Service Letter No. 352

SUBJECT: Modification of Windshield Defroster System

MODELS AFFECTED: PA-24, PA-24-250 Comanches, Serial Nos. 24-2299 to 24-2338, 24-2340, 24-2341, 24-2342, 24-2344 to 24-2360 inclusive, 24-2363 to 24-2369 inclusive, 24-2371 to 24-2379 inclusive, 24-2381, 24-2383 to 24-2396 inclusive, 24-2398, 24-2399, 24-2400, 24-2402, 24-2405, 24-2406, 24-2409, 24-2411 and 24-2412.

SERVICE LETTER NO 352

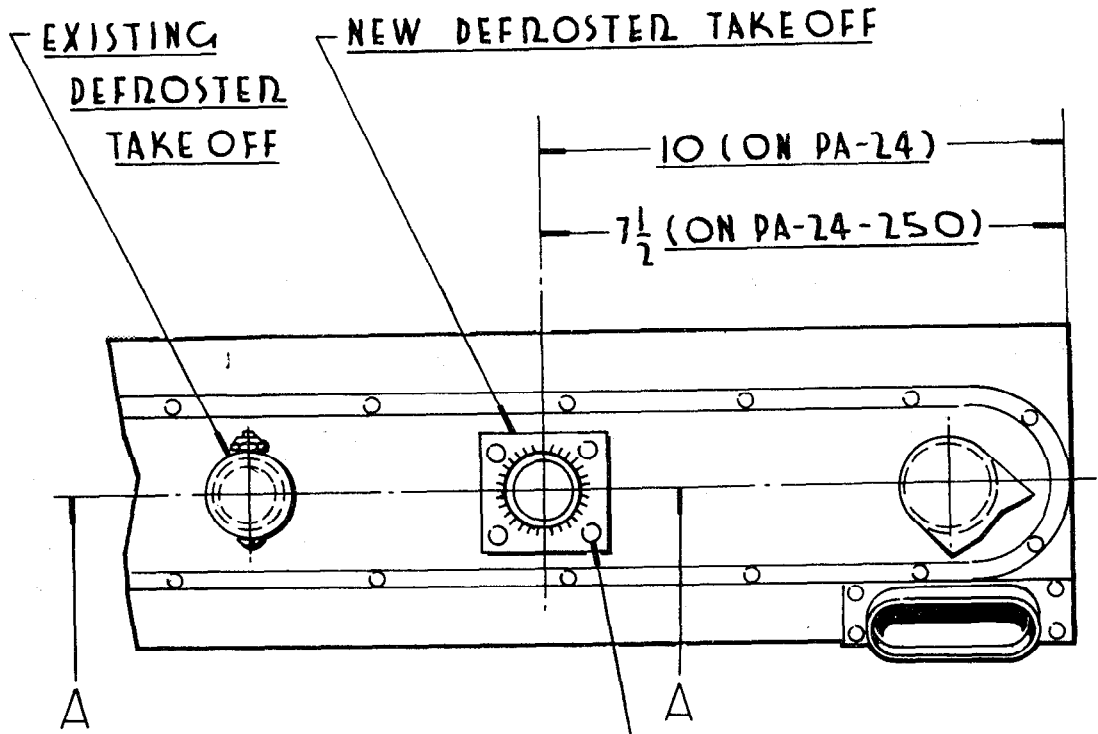
The defroster system as installed on the subject airplanes is capable of delivering hot air to the windshield at a temperature high enough to distort the windshield glass if used on a warm day.

The modification of these defroster systems may be accomplished by referring to the sketch on the reverse side of this Service Letter.

1/4 HOLE (IN DUCT + HOUSING)
(USE EXTREME CAUTION TO
AVOID PUNCTURE OF MUFFLER)
